MASTER DEVELOPMENT DRAINAGE PLAN FOR STERLING RANCH

SEPTEMBER 2018

Project #09-002
SKP-18-003
SF-17-024

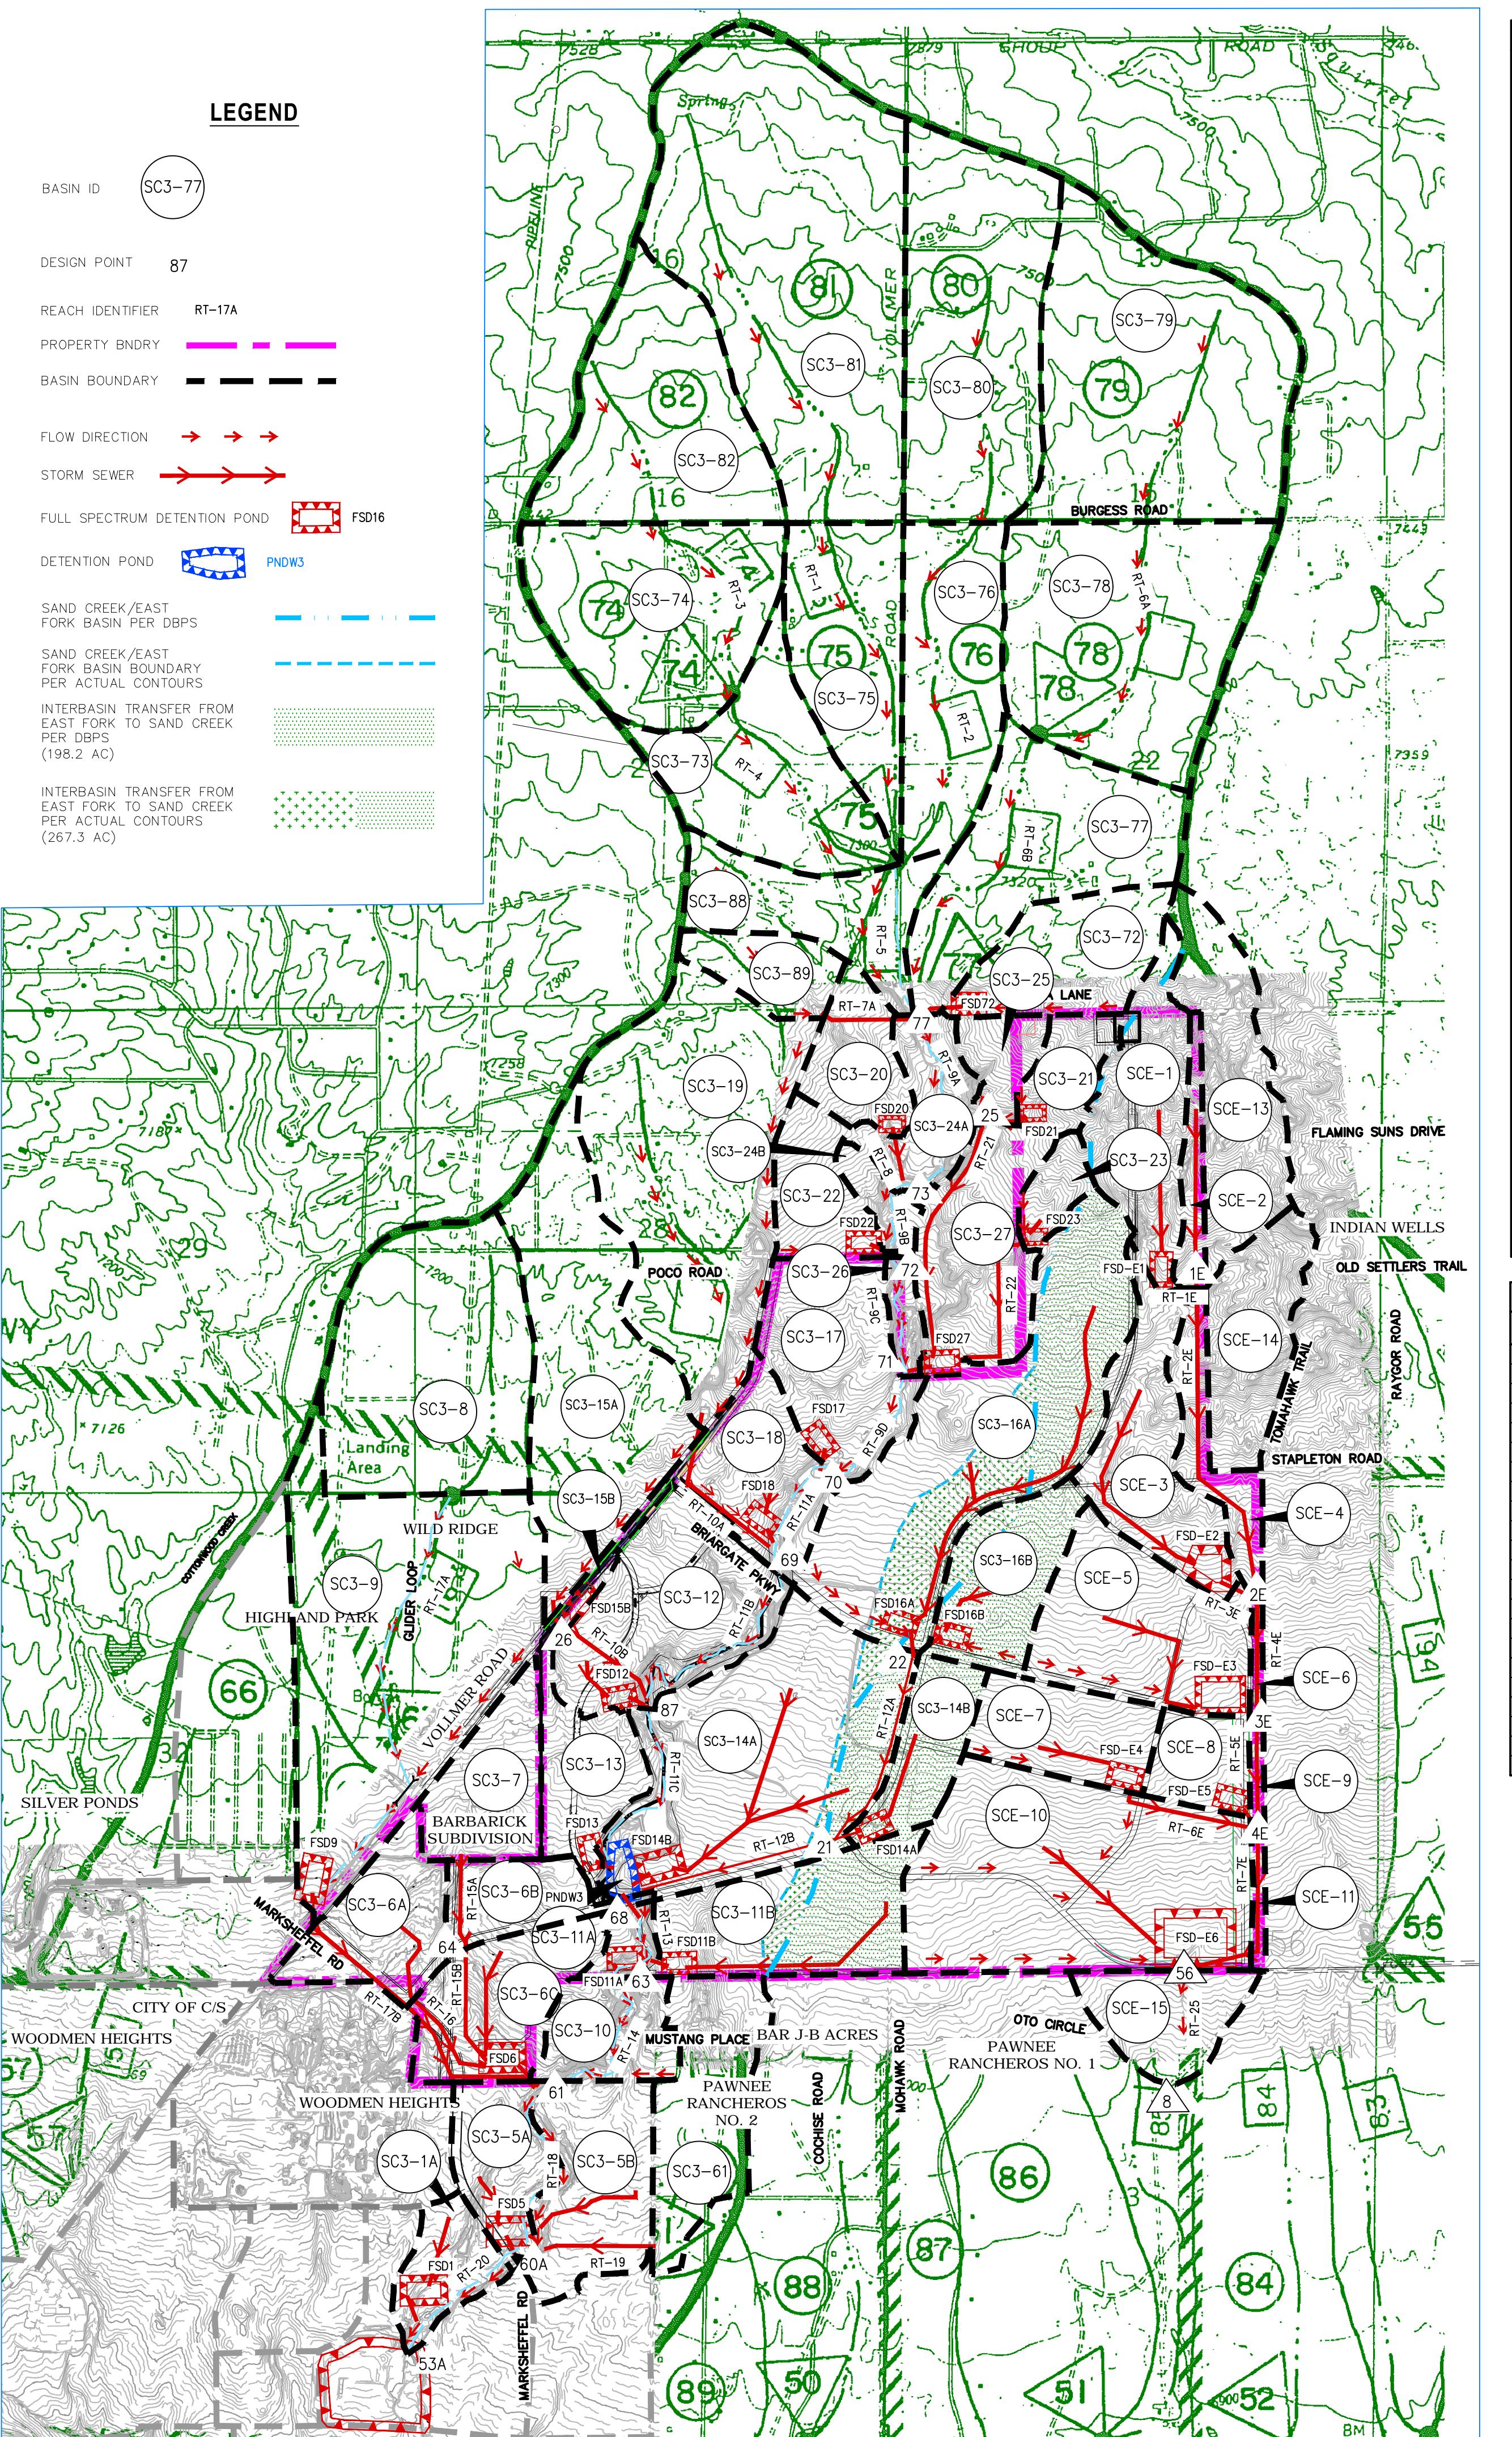
Add corresponding DP/general location after each pond ID.

Q_{100} = 2204.1 CFS (IN)
 Q_{100} = 1350.6 CFS (OUT)
100YR= 78.2 AC-FT

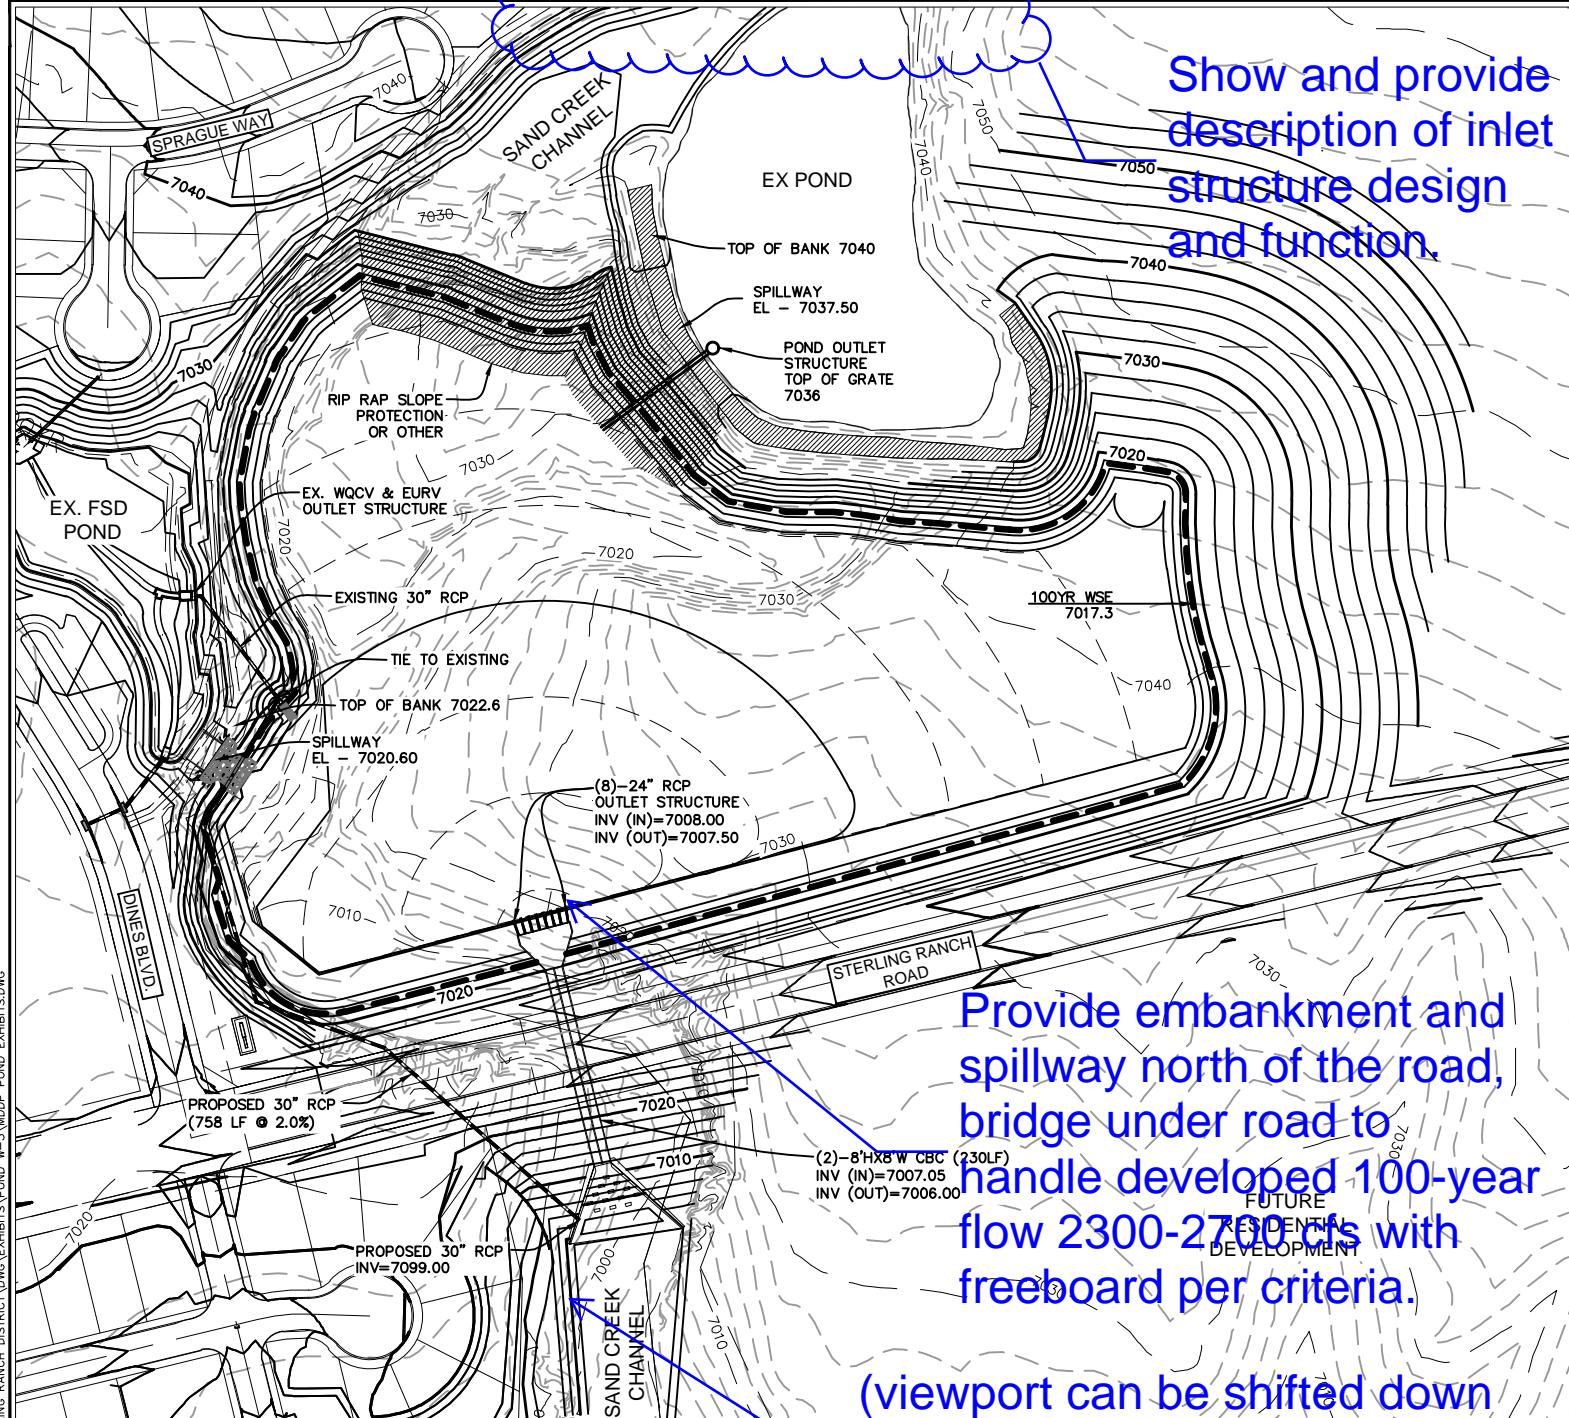
Provide embankment and spillway north of the road, bridge under road to handle developed 100-year flow 2300-2700 cfs with freeboard per criteria.
(viewport can be shifted down to keep the same scale)

Culvert Report

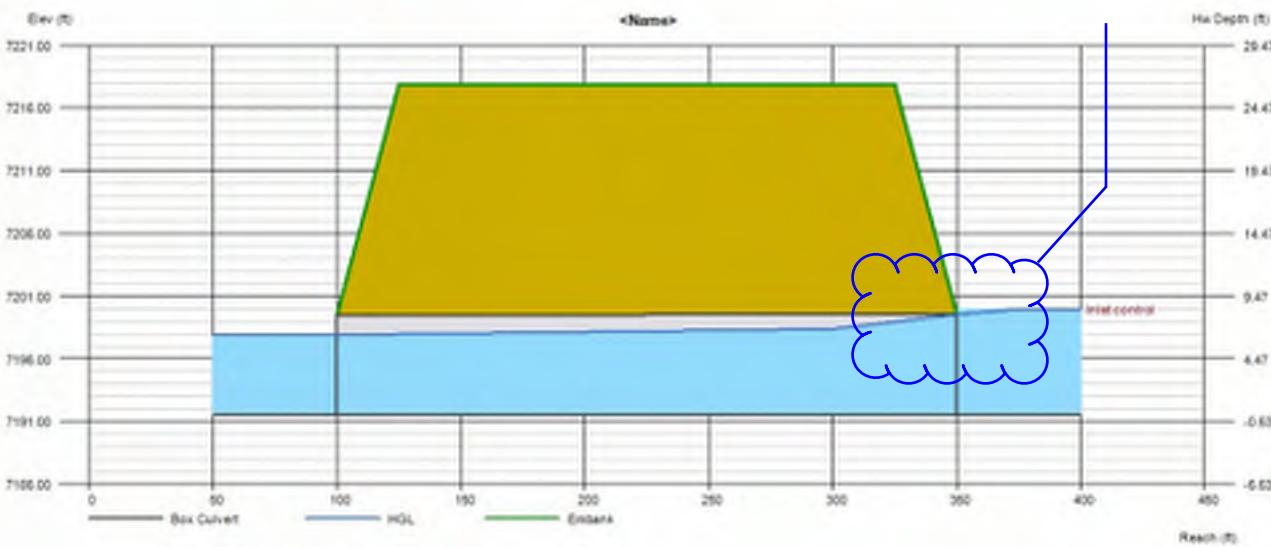
Address bridge
culvert freeboard
requirements

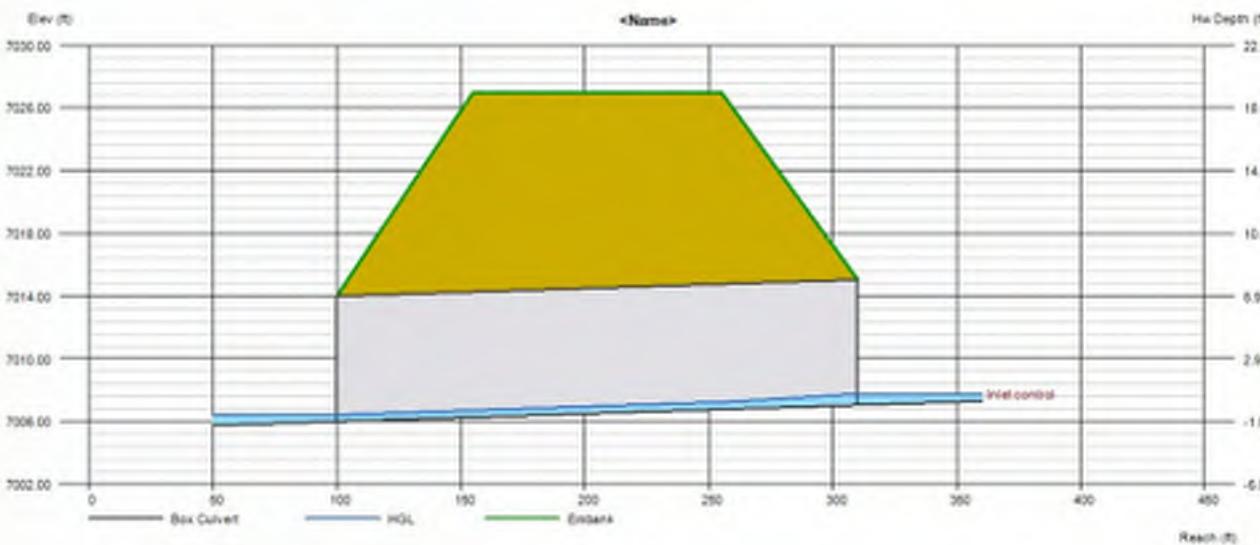
?

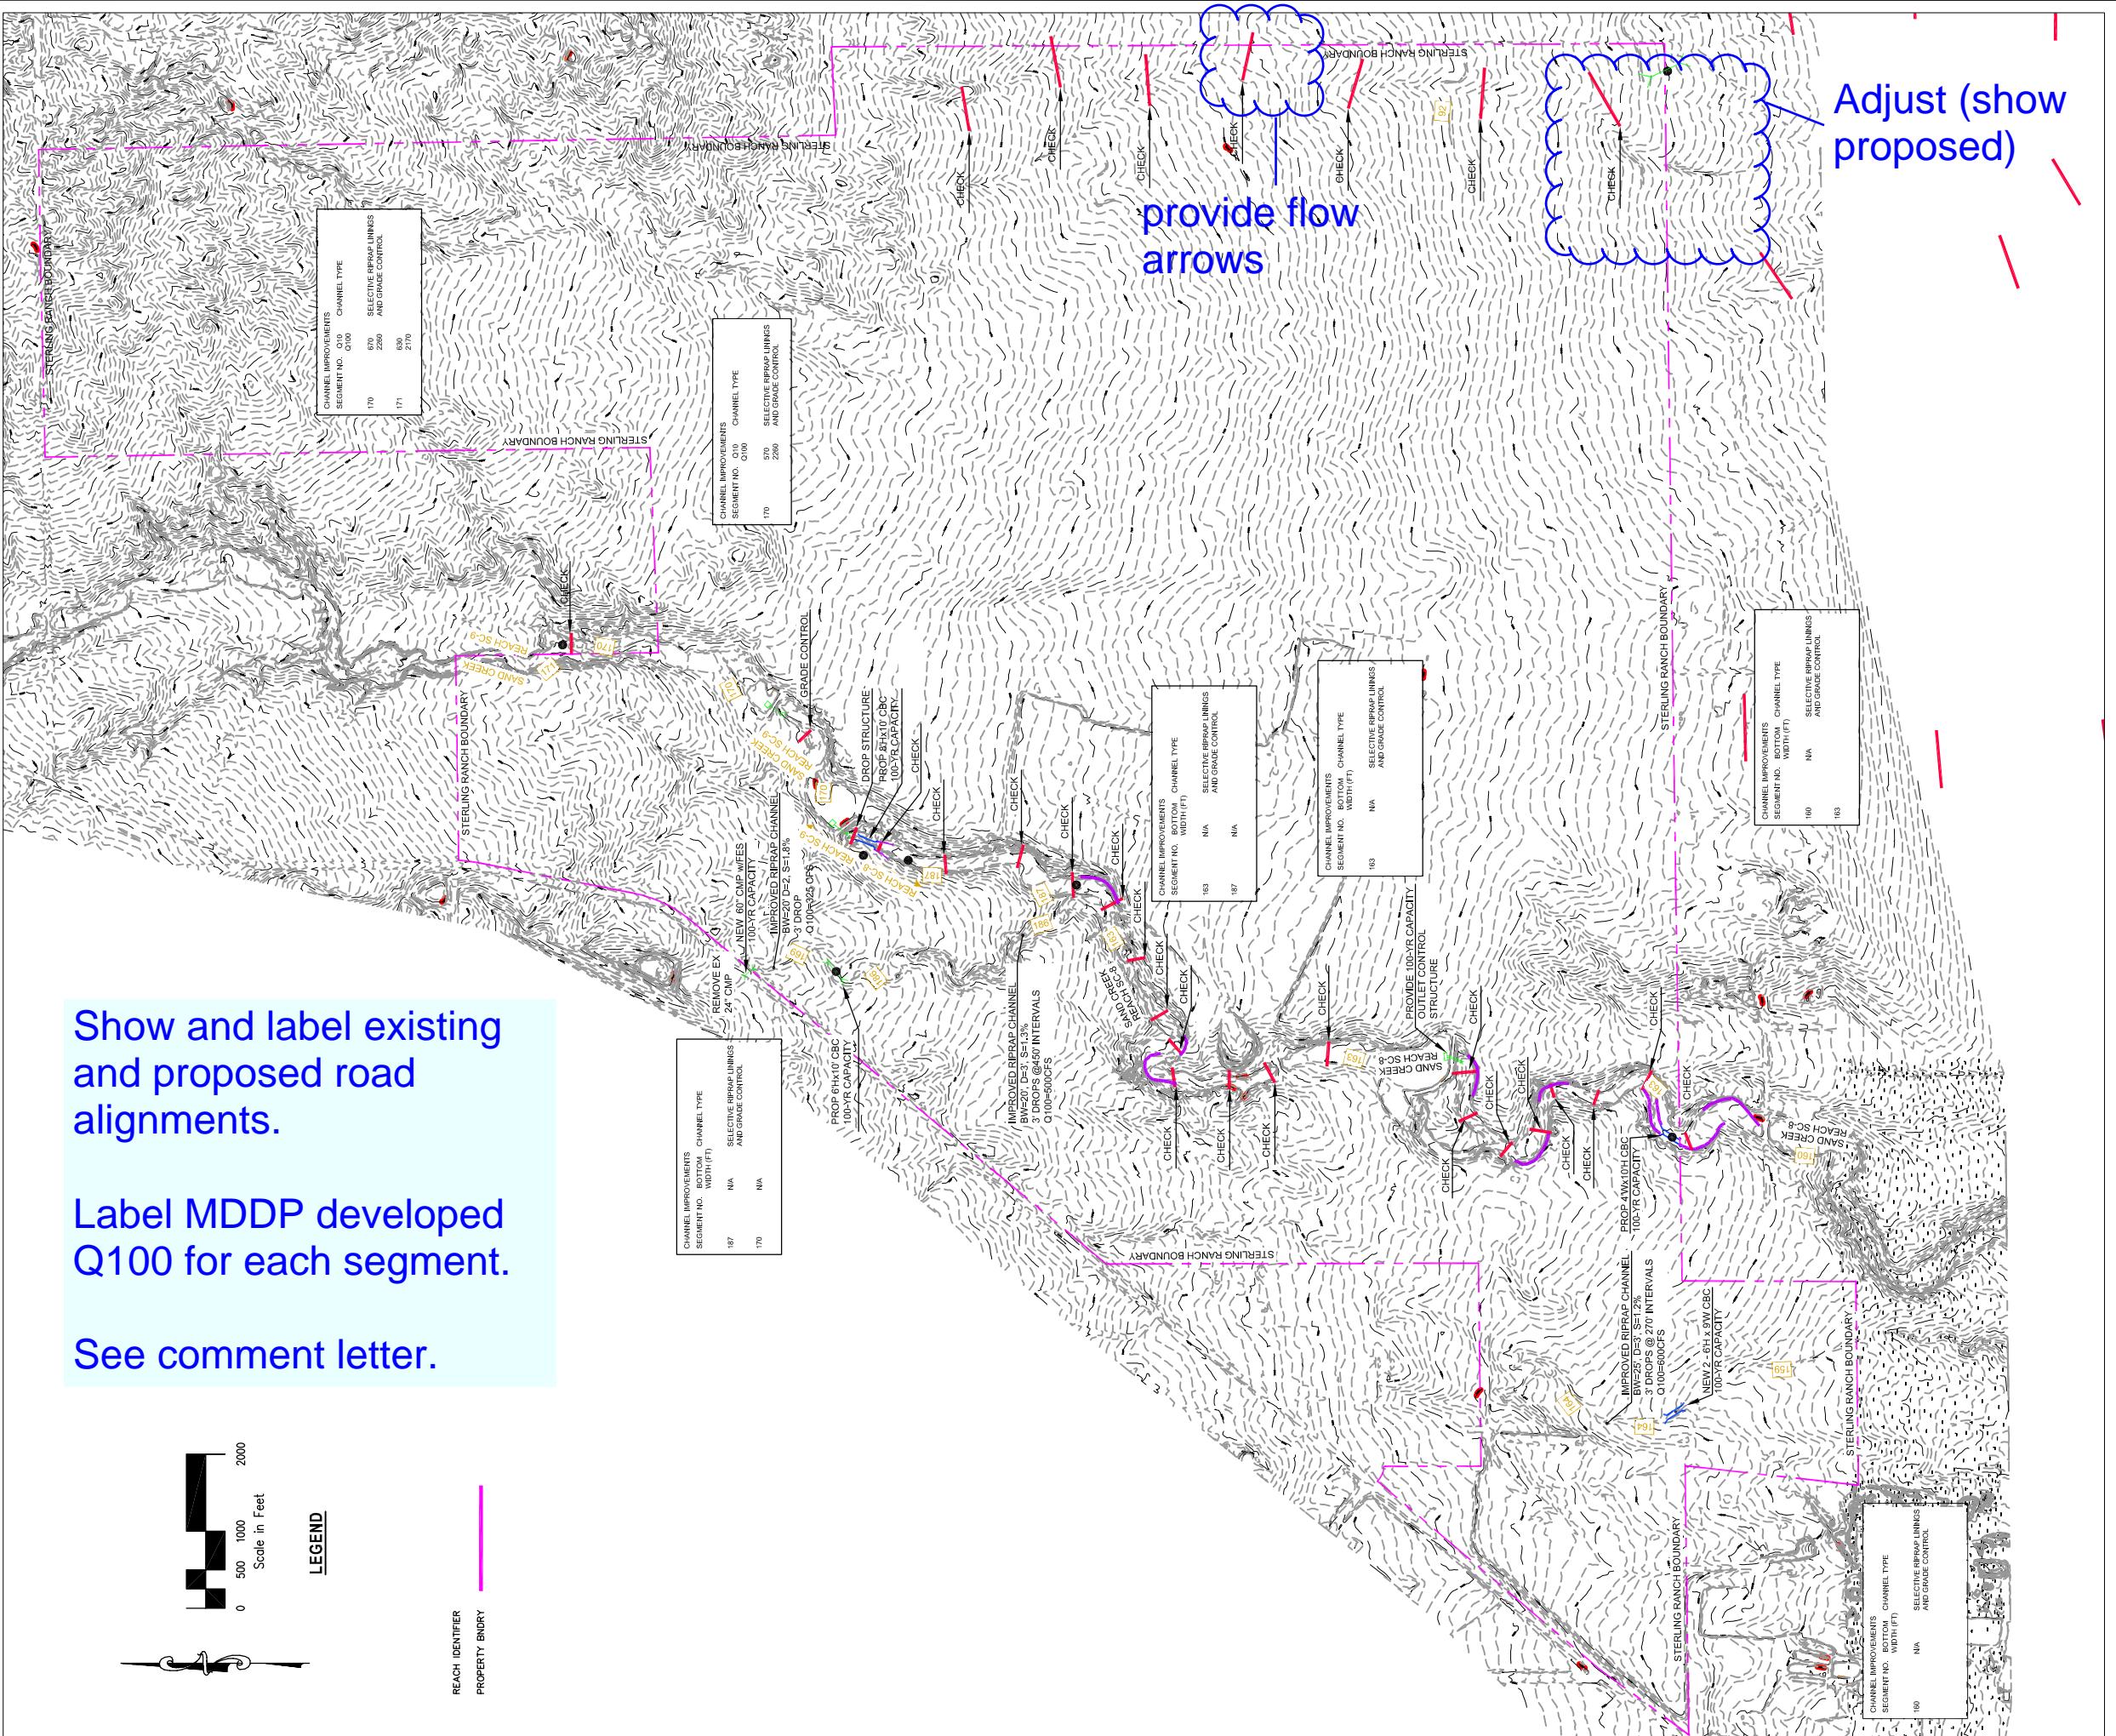
Show and label existing and proposed road alignments.

Label MDDP developed
Q100 for each segment.

See comment letter.

Adjust (show proposed)

provide flow arrows
